**ENVIRONMENTAL REVIEW COMMITTEE REPORT AND  
ADMINISTRATIVE SITE DEVELOPMENT PLAN REPORT & DECISION**

**Project Name:** Kiddie Academy Child Day Care Center

**File Number:** LUA15-000021, ECF, SA-A

**Project Summary:** The applicant is requesting Environmental (SEPA) Review and Administrative Site Plan Review for a new two-story building at the subject site 353 Bremerton Ave NE within the Commercial Arterial (CA) zone. The subject vacant property is located south of the NE 4<sup>th</sup> St and Bremerton Ave NE street intersection on the west side of Bremerton Ave NE. The site is 31,243 sf in area and the proposed building would contain 12,548 sf split between the two floors for the development of a children’s day care center. Other site improvements include play areas with play structures, vehicle parking, monument sign, pedestrian plaza, and landscaping. Existing vehicle access to the site is provided from NE 4th St and Bremerton Ave NE. Existing street improvements within Bremerton Ave NE right-of-way were approved to be retained through a city modification approval. The site is located in the City’s aquifer protection area and no other critical areas are identified on the p

**EXHIBIT 4**

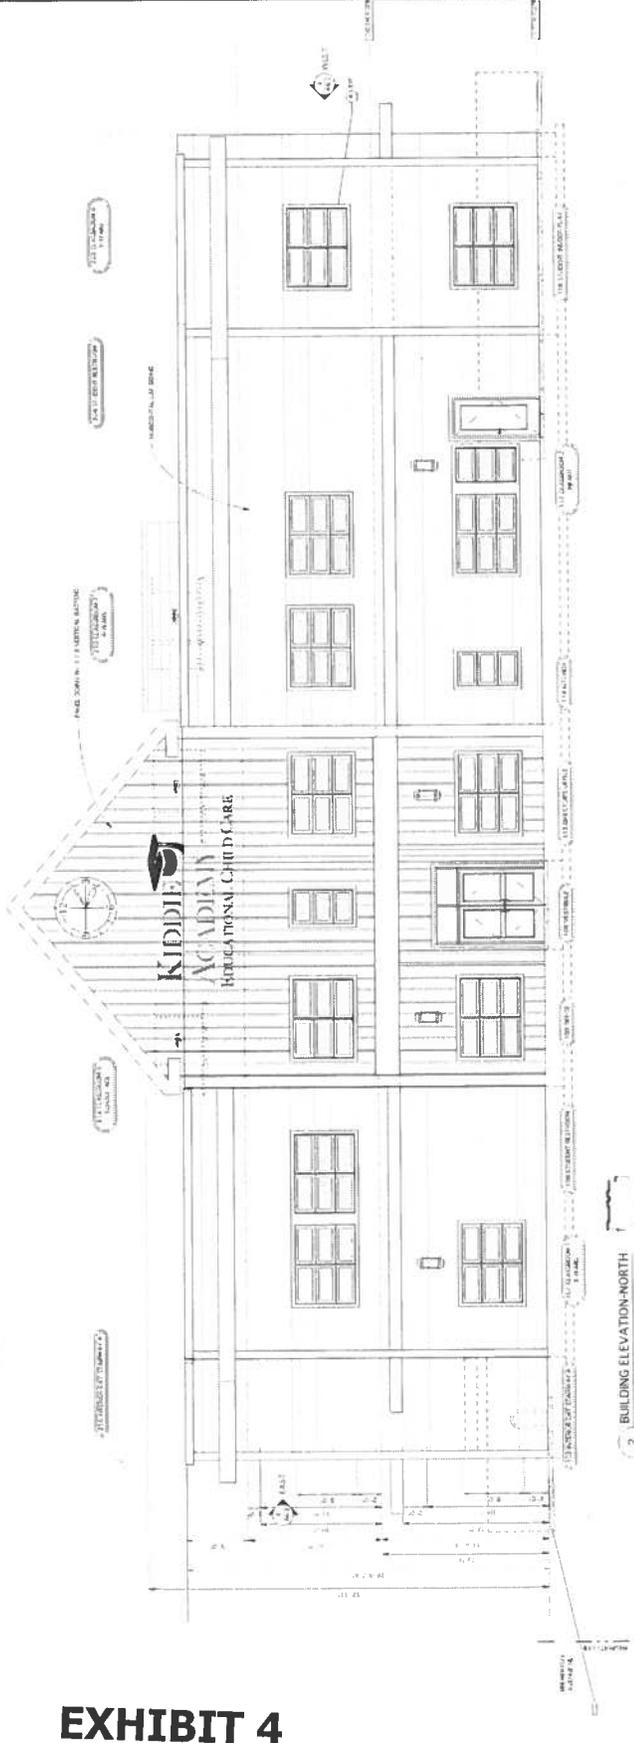
11. The building would have 10 doors on the ground level and the primary entrance and double doors are proposed on the northern façade facing NE 4<sup>th</sup> St (Exhibit 4). The other entrances would be located on the rear southern façade and west façade and provide access to ground floor classroom areas and stairwells.

Therefore, staff recommends as a condition of approval, the Bremerton Ave NE façade be redesigned to include at minimum, windows added to the interior stairwell on the ground and upper levels of a similar size as are used around the building, a projection of the pedestrian level canopy supported by similar styled columns as proposed at the front entry, have multiple sconce lights, and a functioning clock to be placed in the upper gable as is proposed on the north façade or similar features, as approved by the Current Planning Project Manager. The applicant shall update the building façade and provide it to the Current Planning Project Manager, for review and approval, prior to issuance of building permits.

the same type as the doors surrounding the rest of the building, with transparent glazing provided. The applicant shall update the building façade and provide it to the Current Planning Project Manager, for review and approval, prior to issuance of building permits.
N/A	<b>Standard:</b> Buildings with residential uses located at the street level shall be set back from the sidewalk a minimum of ten feet (10') and feature substantial landscaping between the sidewalk and the building or have the ground floor residential uses raised above street level for residents privacy.
<b>2. Building Entries:</b>	
<b>Intent:</b> To make building entrances convenient to locate and easy to access, and ensure that building entries further the pedestrian nature of the fronting sidewalk and the urban character of the district.	
<b>Guidelines:</b> Primary entries shall face the street, serve as a focal point, and allow space for social interaction. All entries shall include features that make them easily identifiable while reflecting the architectural character of the building. The primary entry shall be the most visually prominent entry. Pedestrian access to the building from the sidewalk, parking lots, and/or other areas shall be provided and shall enhance the overall quality of the pedestrian experience on the site.

DATE: 08/11/11  
 DRAWING NO. 15000-01-01  
 SCALE: 1/4" = 1'-0"  
 SHEET NO. SPR-4.1.1  
 TOTAL SHEETS: 4

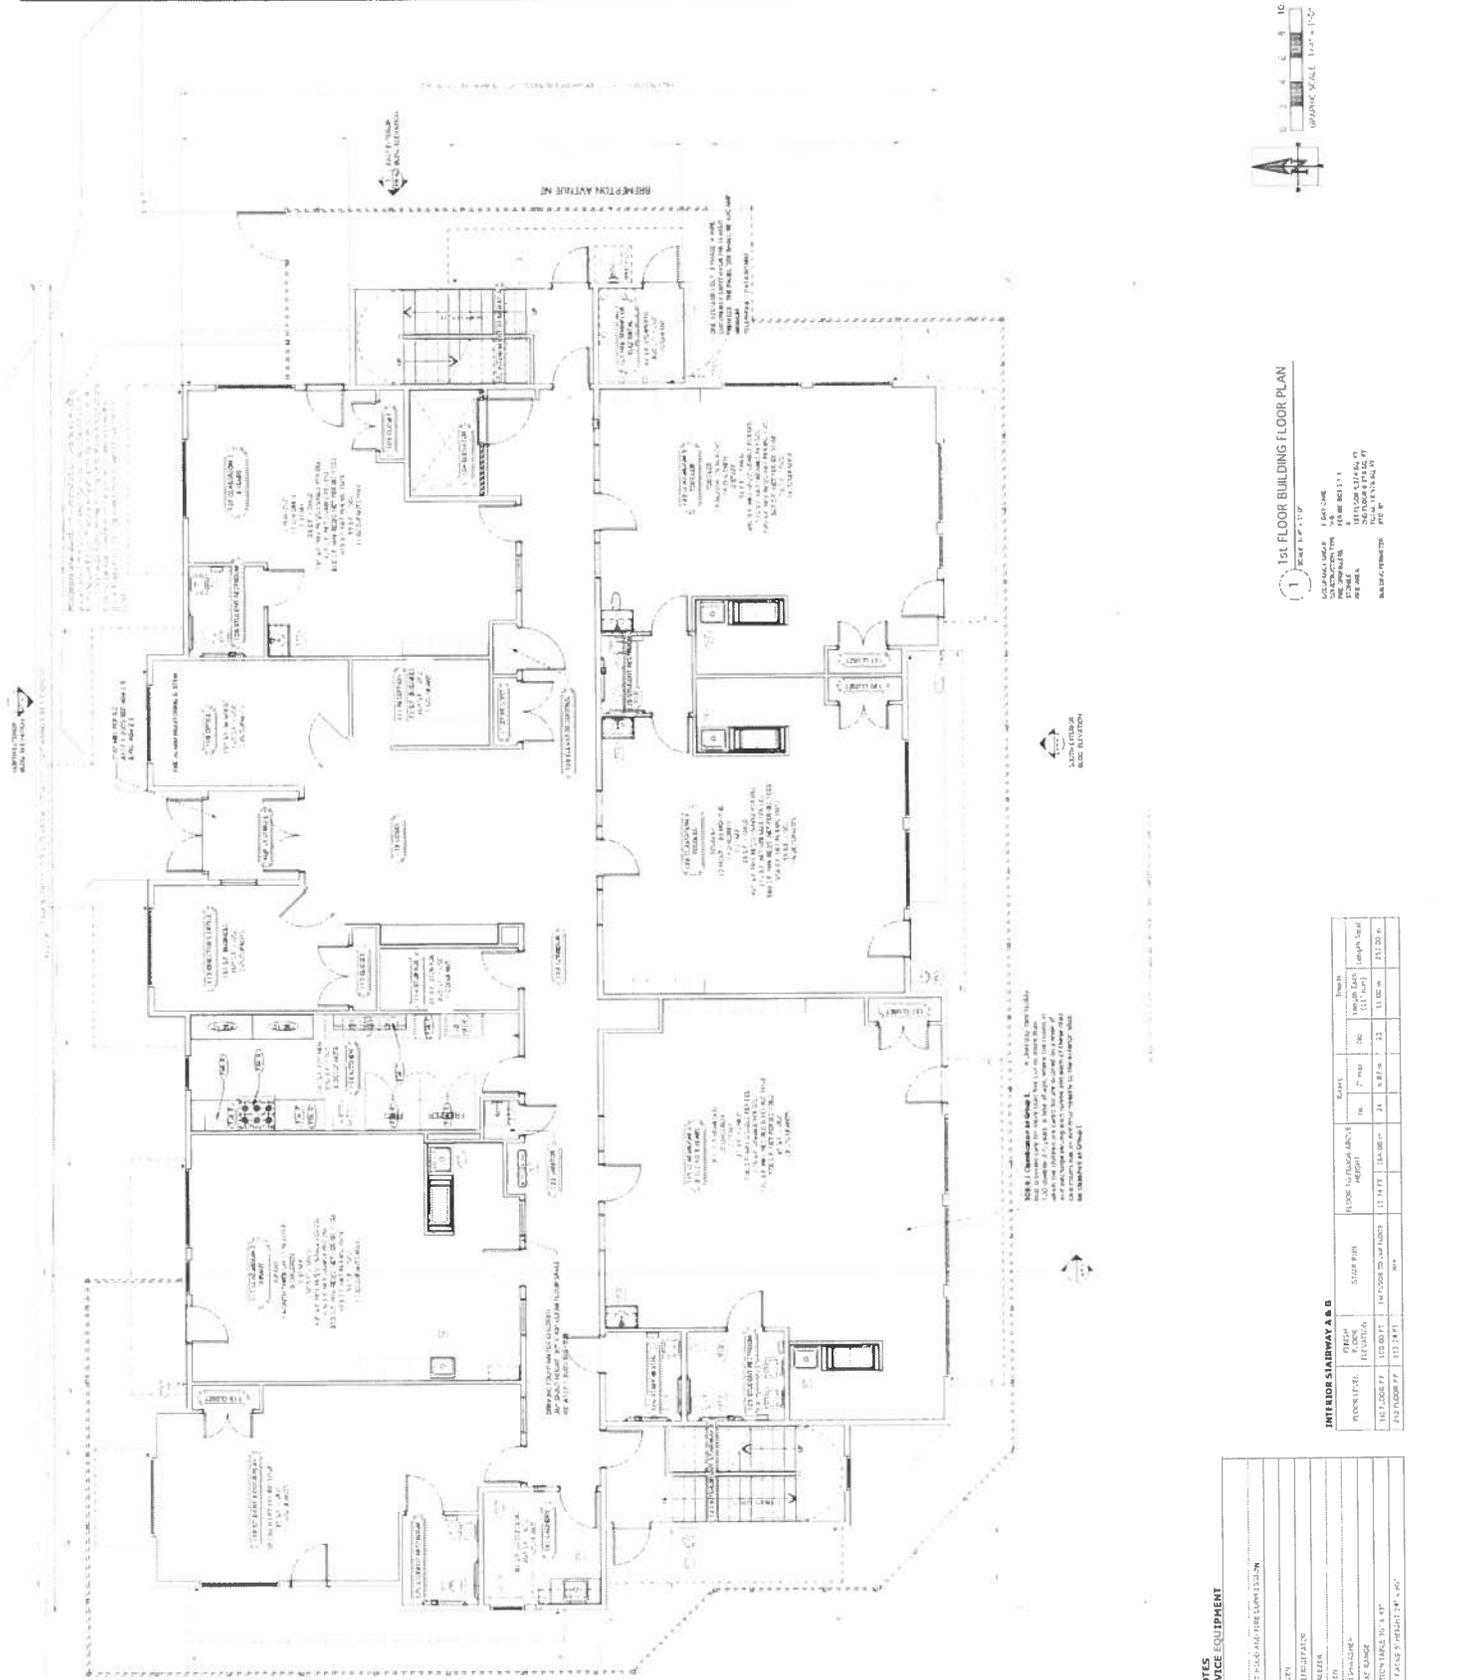
✓	<p><b>Standard:</b> Modulations shall be a minimum of two feet (2') deep, sixteen feet (16') in height, and eight feet (8') in width.</p> <p><b>Staff Comment:</b> As identified on the first floor plan (Exhibit 9), each of the modulations are between 2 feet (west façade) and 8 feet (east façade) in width. Each modulation is articulated vertically from the ground level façade to the upper level of the 2-story structure as identified on the first and second floor plans (Exhibits 9).</p>
N/A	<p><b>Standard:</b> Buildings greater than one hundred sixty feet (160') in length shall provide a variety of modulations and articulations to reduce the apparent bulk and scale of the facade; or provide an additional special feature such as a clock tower, courtyard, fountain, or public gathering area.</p>
<b>2. Ground-Level Details:</b>	
<p><b>Intent:</b> To ensure that buildings are visually interesting and reinforce the intended human-scale character of the pedestrian environment; and ensure that all sides of a building within near or distant public view have visual interest.</p> <p><b>Guidelines:</b> The use of material variations such as colors, brick, shingles, stucco, and horizontal wood siding is encouraged. The primary building entrance should be made visibly prominent by incorporating architectural features such as a facade overhang, trellis, large entry doors, and/or ornamental lighting (illustration below). Detail features should also be used, to include things such as decorative entry paving, street furniture (benches, etc.), and/or public art.</p>

EXHIBIT 10

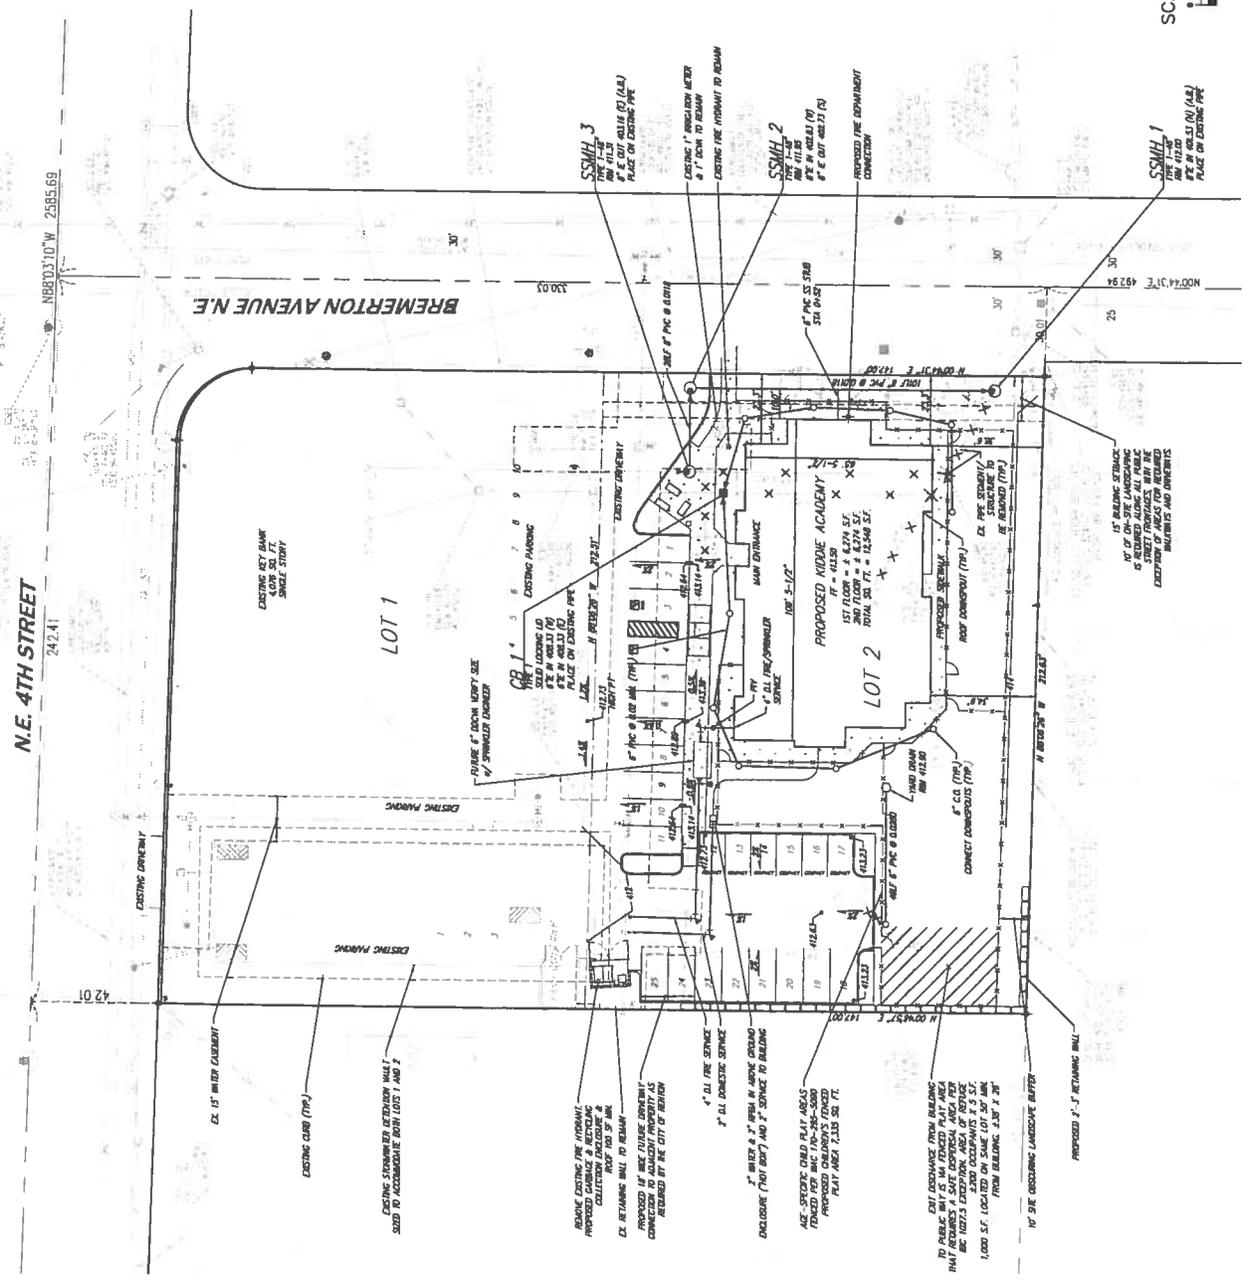
Excavation is estimated at approximately 150 cubic yards based on the submitted Environmental Checklist (Exhibit 18, page 5). A grading plan has been submitted (Exhibit 10) identifying that the proposed site grade would be approximately the same grade as currently exists. The estimated amount of fill is not identified in either the geotechnical report or Environmental Checklist.

12. Approximately 150 cubic yards of cut is proposed on-site (Exhibit 2). Structural fill would be used to grade the site according to the grading plan which is approximately the same grade as what exists and for site improvements that require fill (Exhibit 10).
